STAFF REPORT: 2/9/2022 MEETING

APPLICATION NUMBER: #22-7664

ADDRESS: 2485 BURNS

SCOPE: ALTER FRONT PORCH; ALTERATIONS AT REAR PORCH AND SECOND FLOOR SLEEPING PORCH COMPLETED WITHOUT APPROVAL

Front Porch Alteration

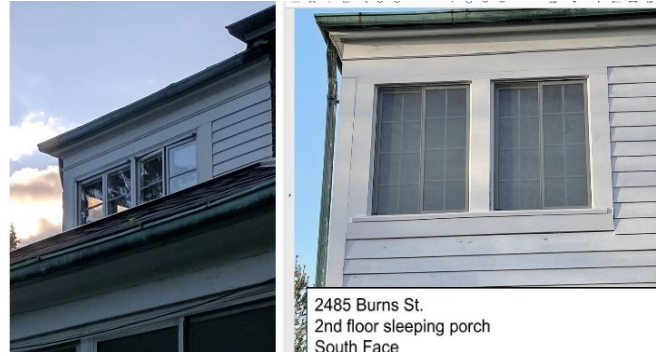
- It is staff's opinion that the introduction of 4x8 cement pavers, replacement of the square form with circular forms, and the introduction of wingwalls destroys the character defining features of the front elevation critical to an understanding of the building's style by obscuring the front elevation windows and introducing a new style and historically anachronistic material, scale and design that is not appropriate.

- It is staff's opinion that the proposal to change the front porch's material from cast stone and limestone to cement block that does not match the house's material nor scale, changing the shape of the front porch to a circular form and introducing "wing walls" that obscure's the front elevation the house's Georgian Revival architecture would destroy the original *scale*, *design*, and *materiality* of this historic property, and therefore does not meet the Secretary of the Interior's Standards for Rehabilitation.

- The top surface of the front porch floor remain the same in dimension, material and size to support the existing columns.
- The proposed lower step of the front porch consist of the same surface material as the original top step or brick that matches in material and scale of the house with a limestone perimeter step.
- The proposed lower step retain the rectangular form as the original step and reach no wider that the outer limits of the first set of windows on either side of the door.
- The applicant provide HDC staff a revised plan of this front porch for review and approval.

Drawing 1, by Applicant: (Southeast) side elevation excerpt from 2017 COA showing approved new knee wall and original columns.

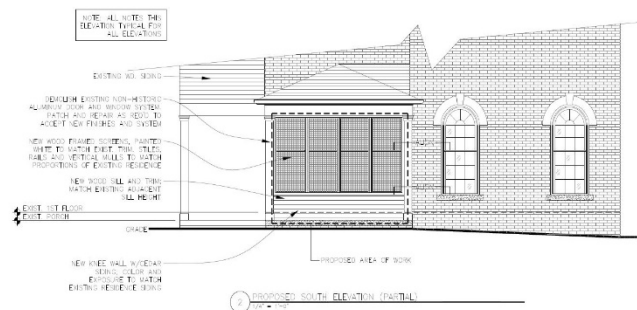
- Staff has the opinion that the open-air quality of the rear, first story screen-in porch, which was approved to introduce a modest knee wall and approved by the HDC in 2017 is a distinctive, character-defining structure. This porch, publicly viewed from the front, had a quality of light transparency with matching character-defining columns that was destroyed by the construction of the solid block massing. This impervious form hides the rear French doors and arched windows (see photos 2-4 & 7) and reads like an addition rather than a porch. Staff also observed that the corner columns of the screen-in porch have been removed on the southwest wall panel and not retained as described in this application. The addition of vinyl transoms over the 2x3 double hung wood windows introduces a new material and pattern that does not complement the existing 3x3 configuration of existing windows of the house.

- It is staff's opinion that the full replacement of the rear screened in porch, which is publicly in view from the front yard with a design that did not conform to the HDC's COA, changes the character from an open air porch to a enclosed room with window and transom configurations that do not match the house has destroyed the original *scale*, *design*, and *materiality* of this historic property, and therefore does not meet the Secretary of the Interior's Standards for Rehabilitation.
